QUANTA
COMPUTER

QUANTA COMPUTER	
CPU HT/CONTROL(1/3)	
Size	Document Number
Custom	AMD
Date: Saturday, March 20, 2010	Sheet 3 of 34

PROJECT : NE8

CHANGE LIST 2

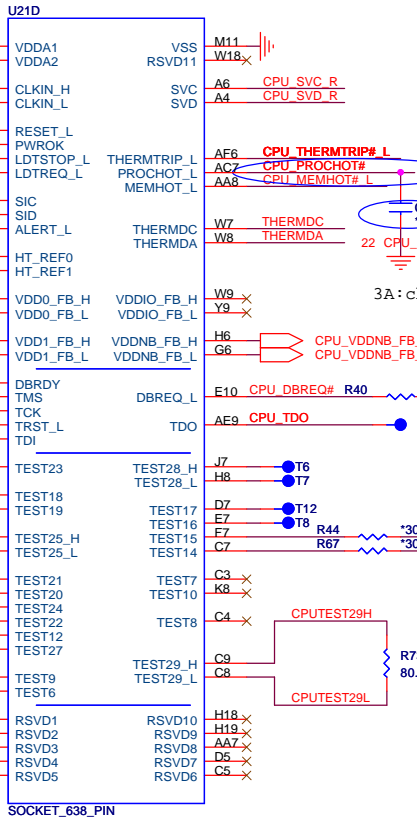
3A:R69 change to short pad

3A:delete R238

3A:addC291 & C137 change from 0.1u to 180pf for power noise

3A:delete con20 & C31 & C267

3A:reserve C184 0.1uF

3A:change Prochot to meet NEO.

3/10
Page 3:add C291 & C137(mount) change from 0.1u(CH4102M9B13) to 180pf (CH11806JB09)
for power noise
Page 3:C31(mount) change from 33pf to 180pf (CH11806JB09)
for power noise

Page 20:Change R330、R321、R346、R347 from 1.5K ohm to 10K ohm for pop noise
Page 20:add C343,C345,C346,C347 10uF for pop noise
Page 8:R86 change from 301ohm to 1Kohm
Page 11:R207& R208 from 100k ohm to 10k ohm
Page 20:R363 umount
Page 18:ML1 & MR4 change to short pad
Page 19:delete Q16
Page21:change con9 from DFTJ08FR085 to DFTJ08FR167
Page22:U13 GPIO66 PL 10kohm(R159)
Page 12:delete R176
Page 15:delete R36
Page 19:con18 delete T39,T40
Page 20:delete R317,R323
Page 20:R214 change from 0ohm to short pad
Page 22:delete R68
Page 3:delete con20 & C31 & C267
Page 3:reserve C182 0.1uF
Page 3:R69 change to short pad

Page20:R206,R205,R215,R210,R209,R222,R211,R217,R223 change to short pad
Page 3:reserve C184 0.1uF
Page21:change LC23 from 1000P/2KV to 1000P/3KV
Page 3:delete R51,R50
Page 4:delete R11
Page20:L1-L4 change P/N to CX121T20100
Page 16:delete RP38
Page 18:delete MRP1
Page 22:delete R155
Page 3:delete R238
Page 15:delete R355
Page 15: R273 change from CS41002JB20 to CS41002FB28

QUANTA COMPUTER		Title	
Size		Document Number	
Custom	AMD	SB8X0 PCI/CLK/LPC(1/4)	
Date:	Saturday, March 20, 2010	Sheet	10 of 34

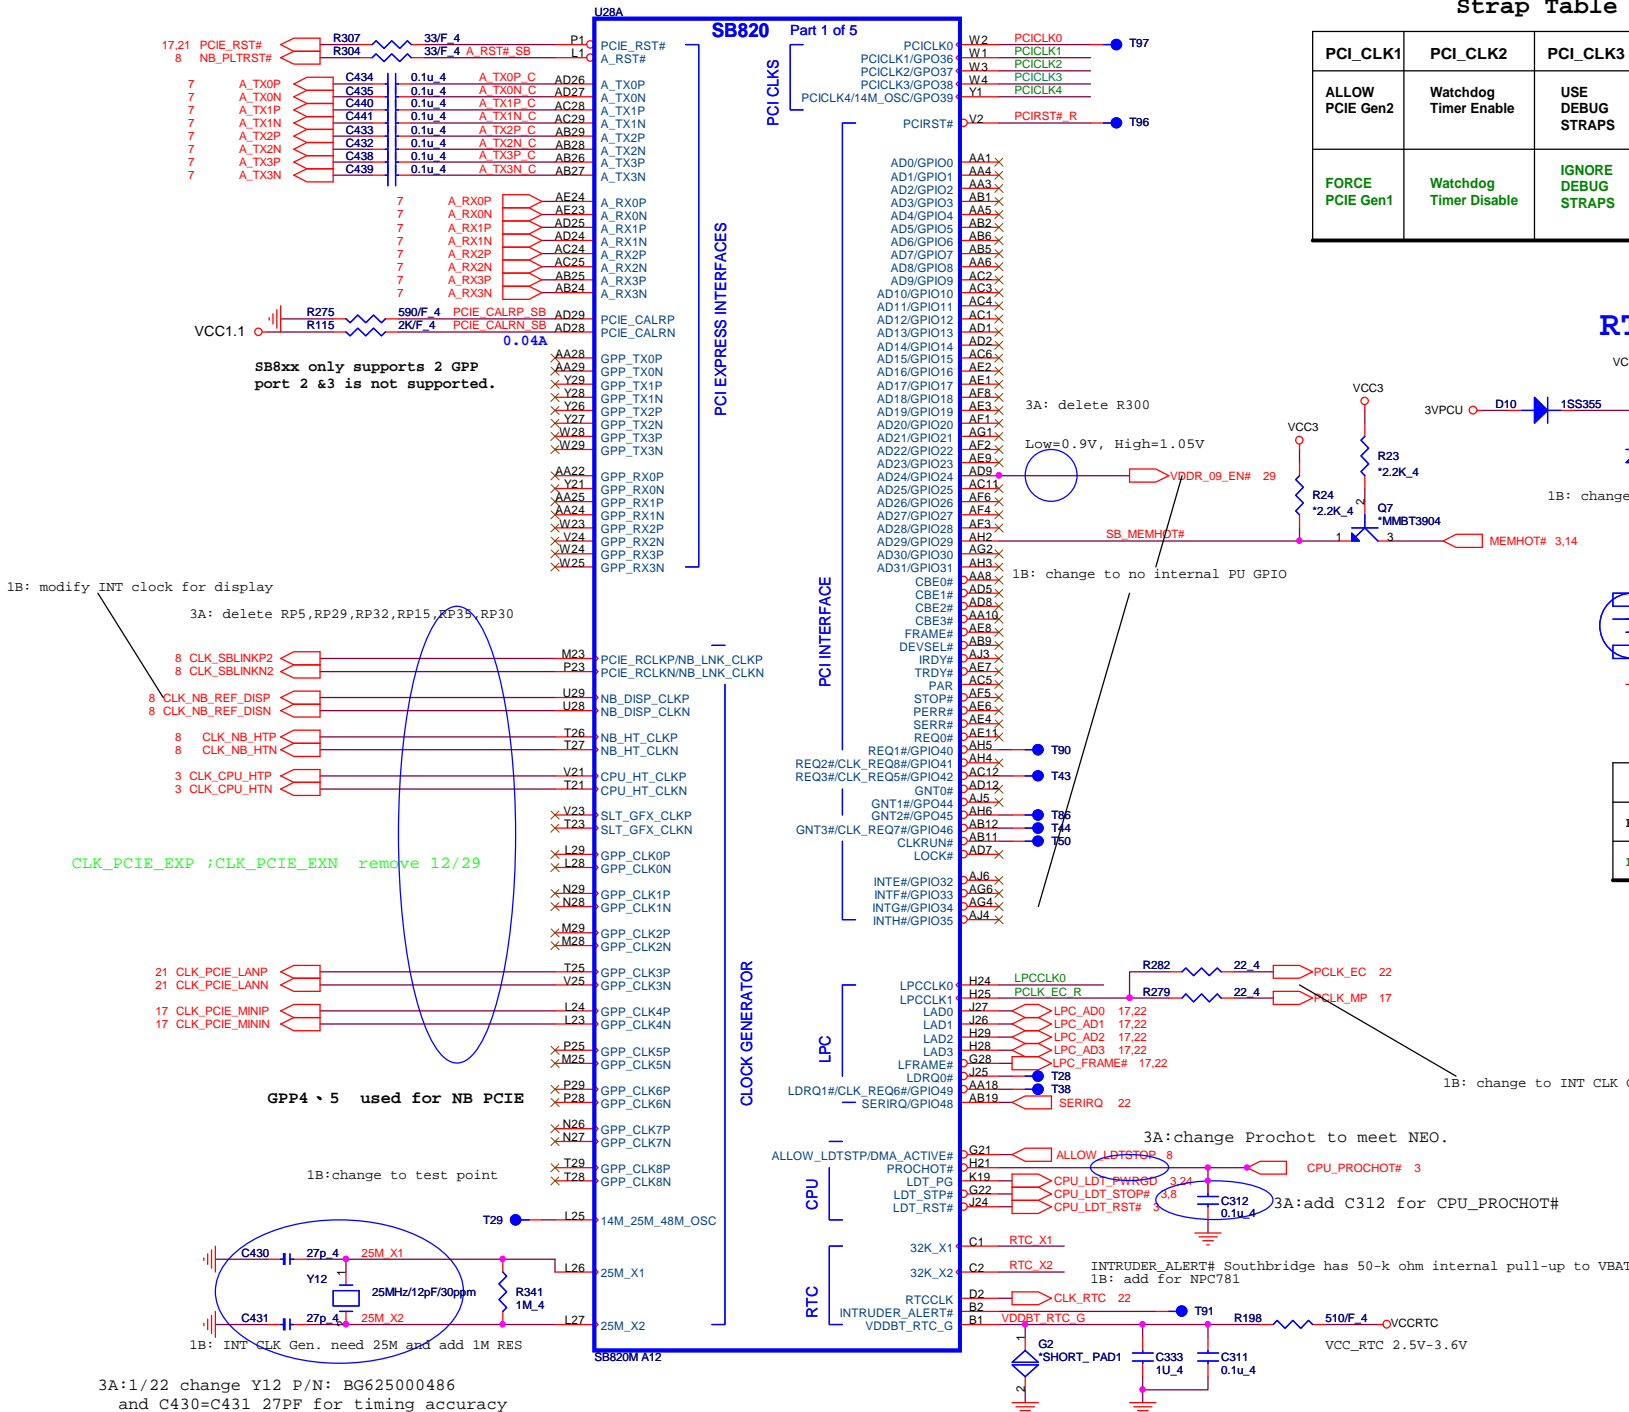
1221,AMD suggest R309 unimpunt

1B: delete no need PU R128/R161/R272/R155, add R354 for optional

3A:1/22 change Y7 P/N(BG332768909) and C478=18PF for timing accuracy

1/21---->改版<VT
Page 21:L01 pin26 ISOLATE# add 15kohm PD
1/22
Page 10: Y7 change P/N:BG332768909
C478 change to 18PF

SB8X0 SATA(2/4)

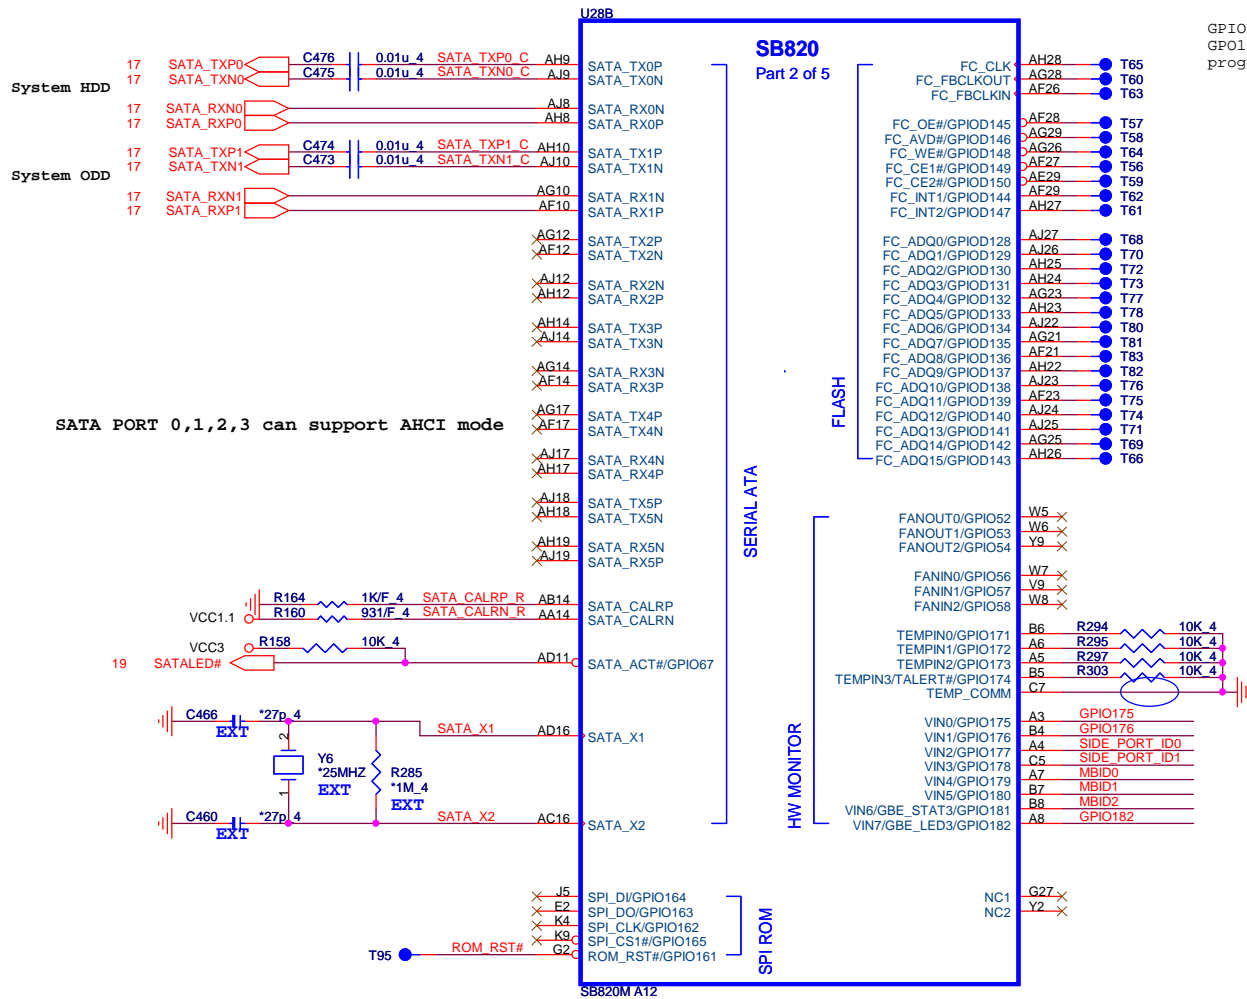
```
3A Remove Panel ID      3A :delete RP27,SW1,RP25
```

Page 11:delete RP27,SW1,RP25 (remove Panel ID set)

Title		
HDMI		
Size B	Document Number	Rev 3A
	AMD	
Date: Saturday, March 20, 2010		
Sheet 16 of 34

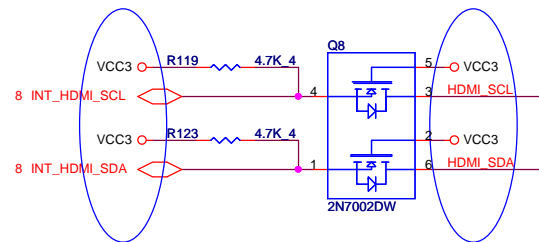
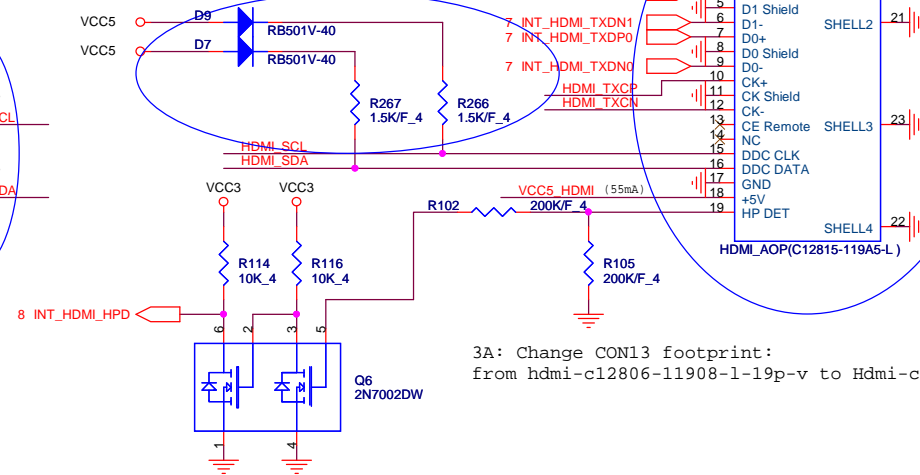
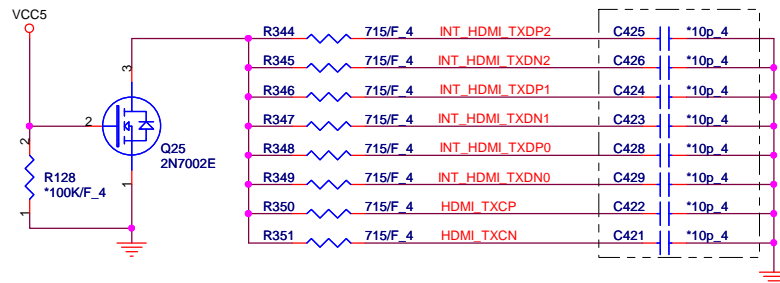
3A: change power source for CRT port

3A: change power source for
HDMI port

3A:delete RP38

3A : VCC5 -> VCC3

3A:Prevent incorrect voltage level

3A: Change CON13 footprint:
 from hdmi-c12806-11908-1-19p-v to Hdmi-c12825-11908-1-19p-v

3/5
Page16: change power source for CRT port

Page16: change D9,D7 P/N and mount R266,R267

Page 24: Change PC 142 footprint ECAP10X6S-Z01
Page 16: Change CON13 footprint & P/N:
from hdmi-c12806-11908-1-19p-v to Hdmi-c12825-11908-1-19p-v
3/9
Page 23: delete L27
Page6 & Pagell: remove all side port component

QUANTA COMPUTER	
Title: CARD READER(RTS5186)	
Size: Custom	Document Number: AMD
Date: Saturday, March 20, 2010	Sheet: 18 of 34

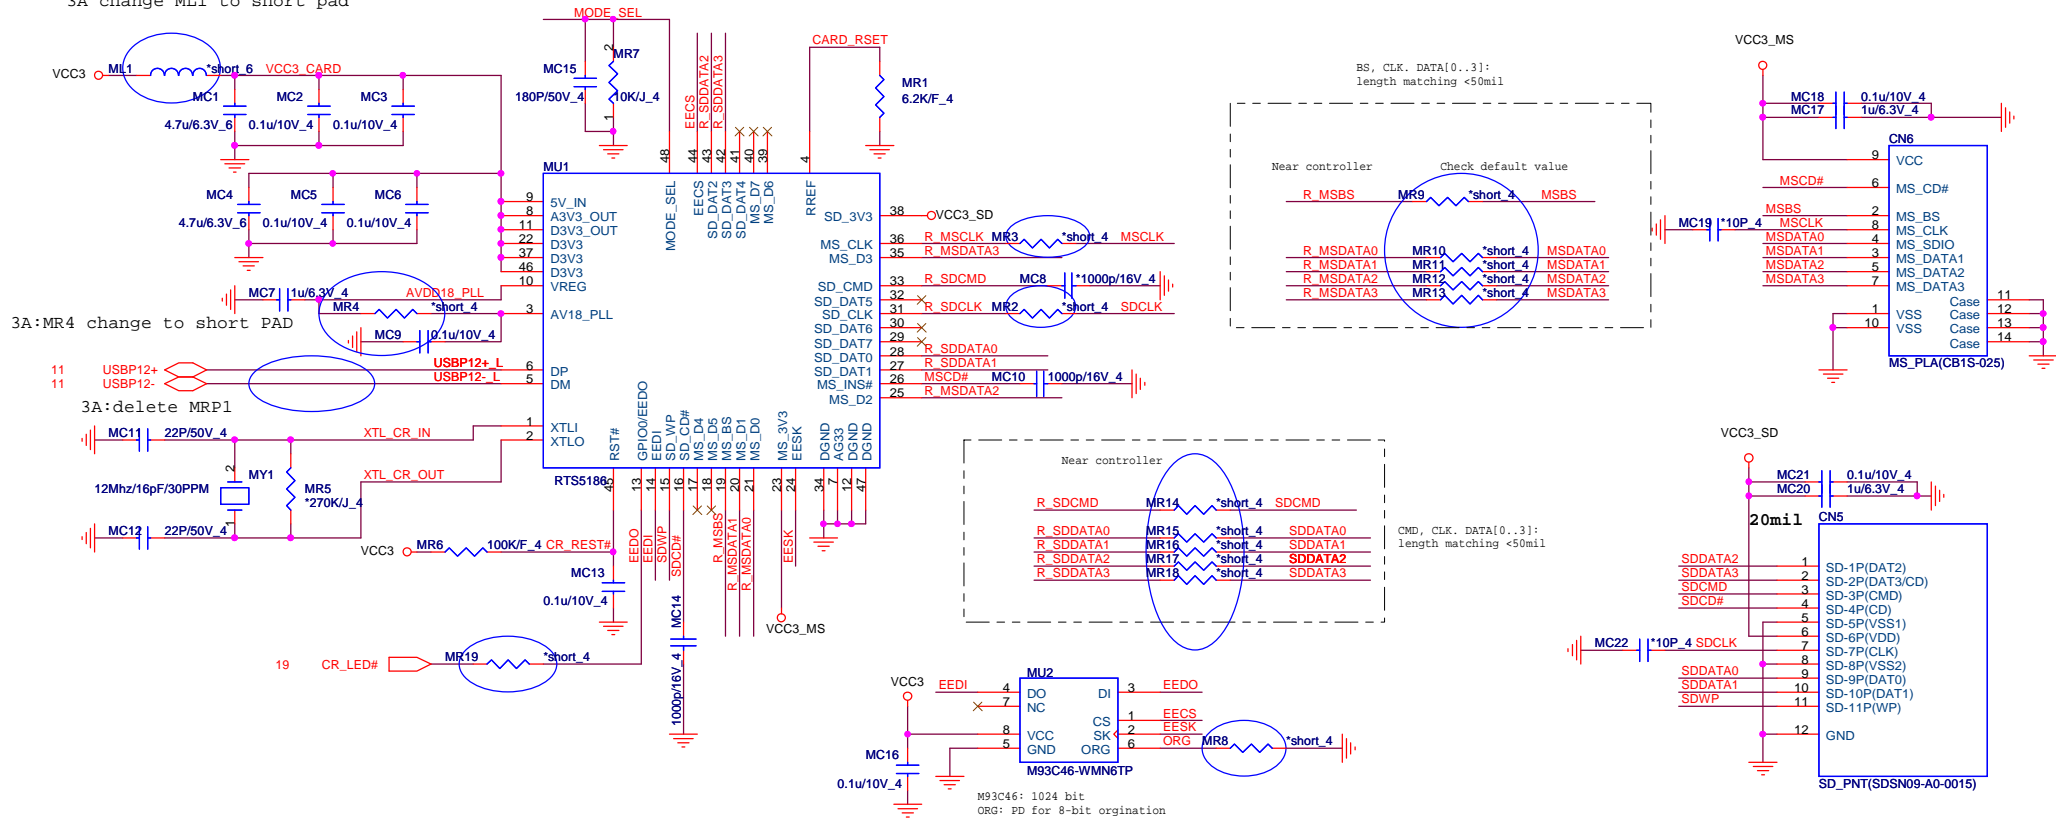
3A:Change MR19,MR3,MR2,MR9,MR10,MR11,MR12,MR13,MR14,MR15,MR16,MR17,MR18,MR8 to short pad

3A change ML1 to short pad

Page 18:Change MR19,MR3,MR2,MR9,MR10,MR11,MR12,MR13,MR14,MR15,MR16,MR17,MR18,MR8 to short pad

Title			
Express Card/LED/BT			
Size	Document Number	Rev	3A
Custom	AMD		
Date	Saturday, March 20, 2010	Sheet	19 of 34

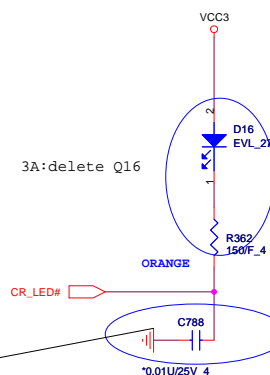
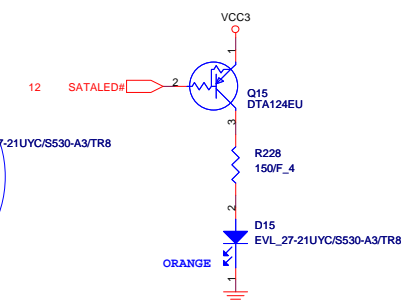
3A : Reverse C786, C787, C788 FP for ESD

Page 32:change H13,H15,H17,and add H23,H24 NUT
Page 19:Reverse C786, C787, C788 FP for ESD
Page 20:C342 umount
Page 20:CPU_PROCHOT# add C312
Page 9:mount C217 for DYN_VCC1.1 power ripple too large

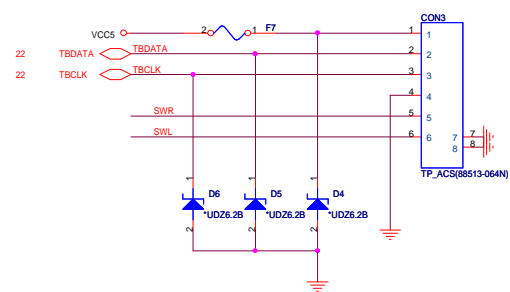
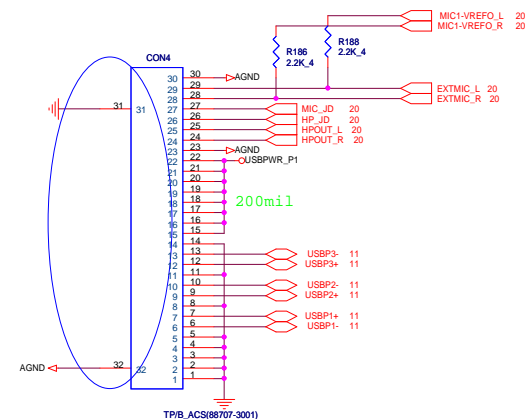
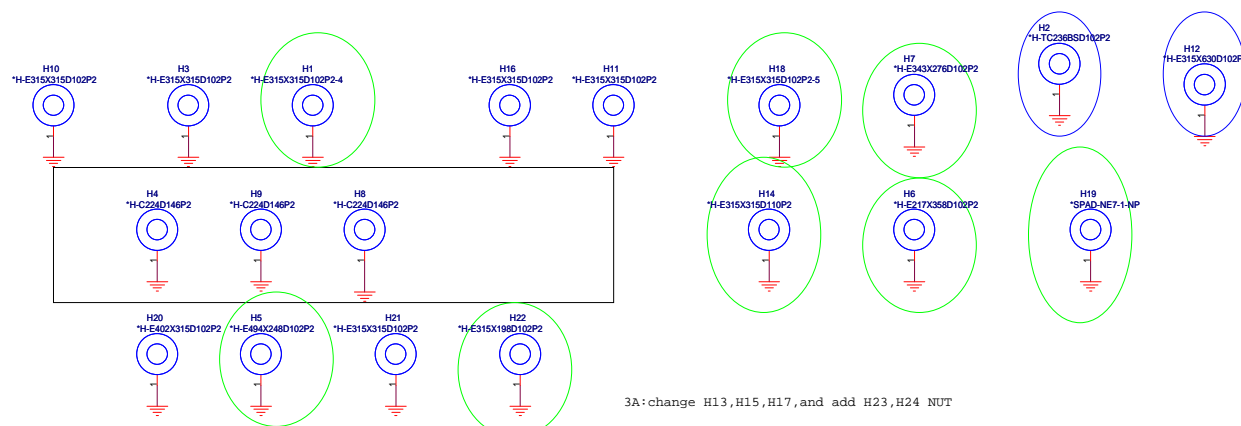
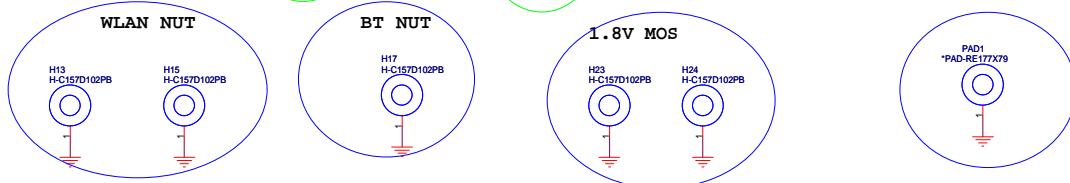
3A: change R236,R237 from 150 ohm to 75ohm for two color LED

3A change from 88511-3001 to 88707-3001

3A: change H13,H15,H17, and add H23,H24 NUT

3/20
Page 32: change R236,R237 from 150 ohm to 75ohm for two color LED
